Access Compliance Report

Public Rights-of-Way

(Pedestrian Signals)

Intersection ID: N/A	Main Street:	Cross Street: N/A	Location: N/A
ADA ID: CD52344944DC	Signal Type: One Push Button-APS	Overall Compliance: No	Severity Score: BTN 1: N/A BTN 2: N/A No BTN: N/A
Codes/Mitigation Info/Possible Solution		Field Measurements/Component Compliance

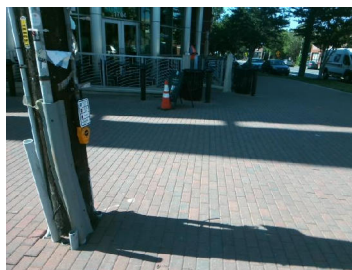
Surveyor Notes: TEXT HT 3/8

PROW/ADA: R410.6, TMUTCD 4e.08, R209.1, MUTCD 4e.10

Yes	B 1 Clear Xing Direction?	ClearlyMarked	N/A	B 2 Clear Xing Direction?	N/A
	B 1 Crossing Direction	To N		B 2 Crossing Direction	N/A
No	B 1 DistanceTo XWalk (in)	125.0	N/A	B 2 DistanceTo XWalk (in)	N/A
No	B 1 DistanceTo Curb (in)	128.0	N/A	B 2 DistanceTo Curb (in)	N/A
Yes	B 1 Diameter (in)	2.0	N/A	B 2 Diameter (in)	N/A

Possible Solutions: Replace Signal Push Button With APS Button on New Post. Remove & Replace Sign.
